Notice of Allowability

10/074,641

SEZGIN ET AL.

FIG. 1

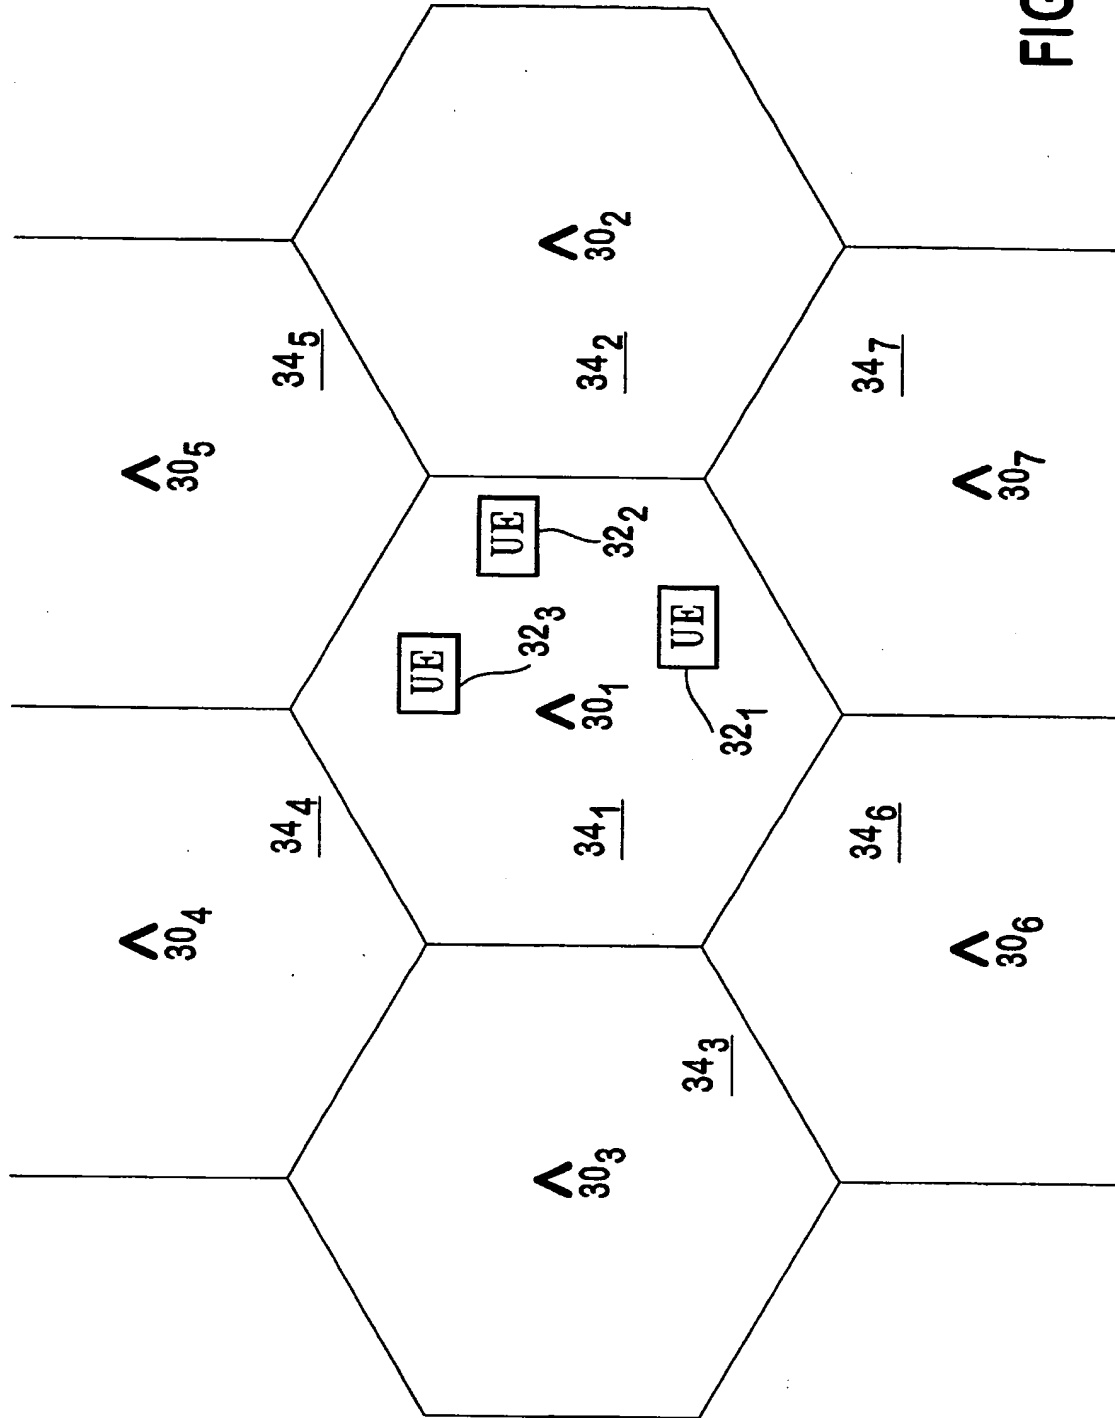
- In the drawing, **FIG. 1, 2, and 3** have been designated by a legend --**Prior Art** - - (see attached)
- Claim 1, line 5, "**a primary synchronization signal**" has been replaced with -- **the primary synchronization signal** - -
- Claim 5, line 6, "**a primary synchronization signal**" has been replaced with -- **the primary synchronization signal** - -
